TECHNICAL SERVICE BULLETIN

October, 1971

Recall Campaign # Z.102
U.S. Safety Weave 201
Seat Belts

TR-250, Spitfire,
GT-6 & TR-6

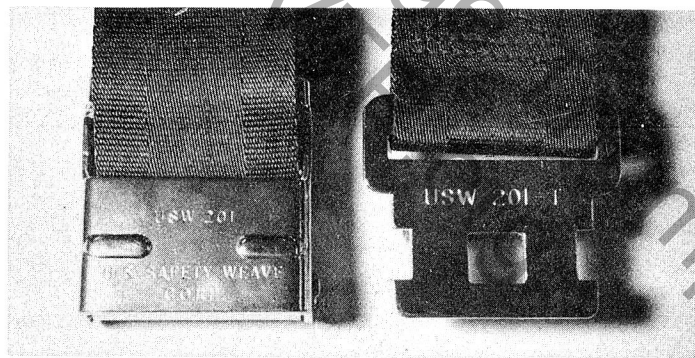
These belts were supplied by U.S. Safety Weave Co. and can be identified by the symbol "USW 201" on the reverse side of the buckle and tongue as illustrated:

It will therefore be necessary to replace all U.S. Safety Weave belts bearing the above symbols on Models listed below at no charge to the customer.

Replacement seat belts under the following part numbers can be ordered from your Distributor.

<u>Part #</u>	<u>Type</u>	<u>Models</u>
V571	Lap	TR-250 Spitfire TR-6
V539	Lap/Shoulder	GT-6
